From: Richard Waller | Peter Rayment Design]
Sent: 23 February 2021 17:41
To: Kelsey Blain
Subject: RE: nym/2020/0986-Selbourne House-Robin Hoods BAy

title:	AS PROPOSED	dwg No:	2036-401	rev:	B
project:	Replacement windows & erection of garden wall at Selbourne House, RHB	scale:	1:50 @ A1		
client:	Mr & Mrs Rajab	date:	10.12.2020

as proposed principal elevation
south -1:100

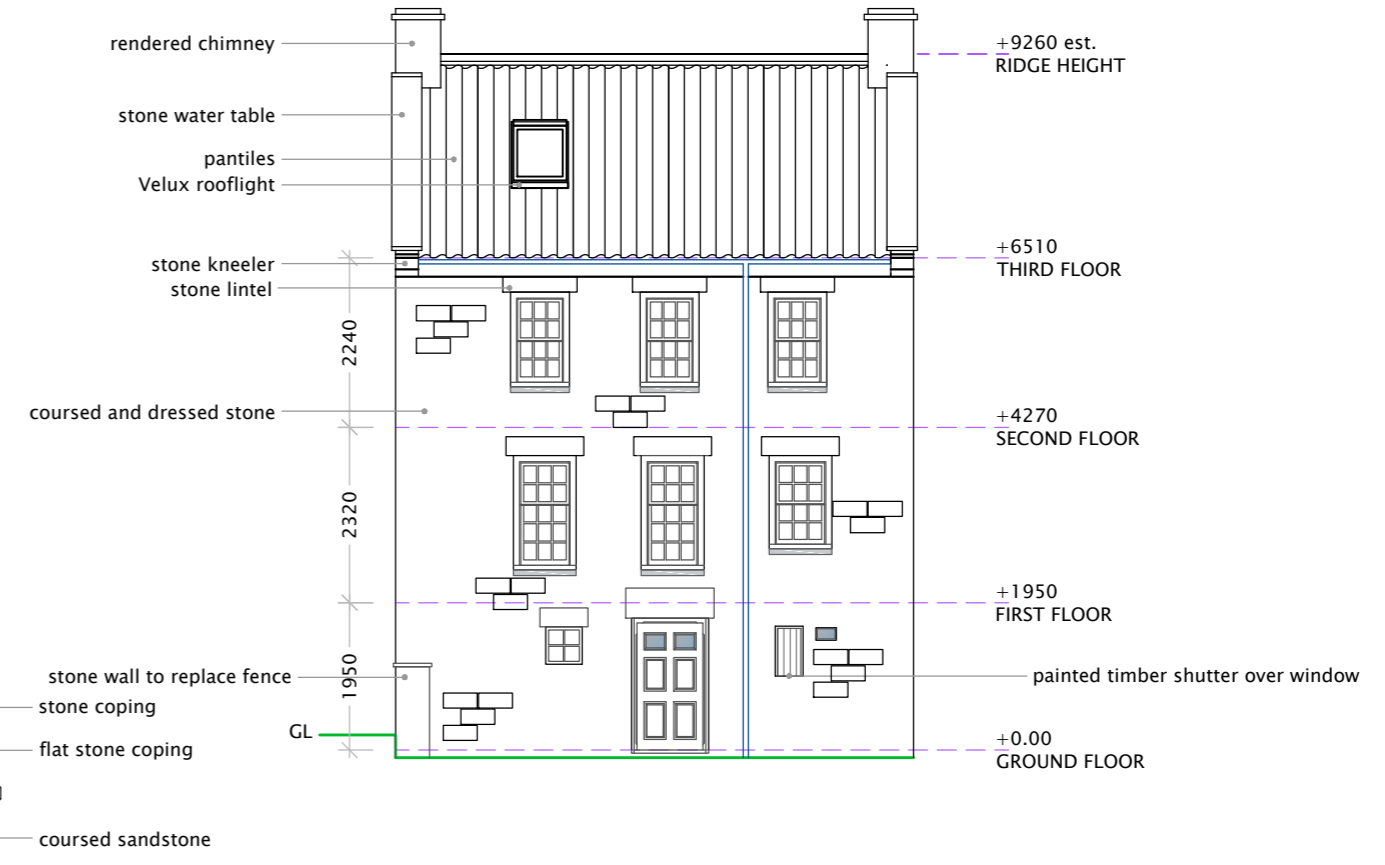
Thank you for the prompt response. In light of your email the applicant has for now removed the stable door from the proposed works. The existing door will remain in place.

I have attached a revised drawing 2036-401-B to show the entrance door left as is.

rev	description	date
A	addition of west elevation to include boundary wall.	12.01.2021
B	entrance door to s. elevation removed from application	23.02.2021
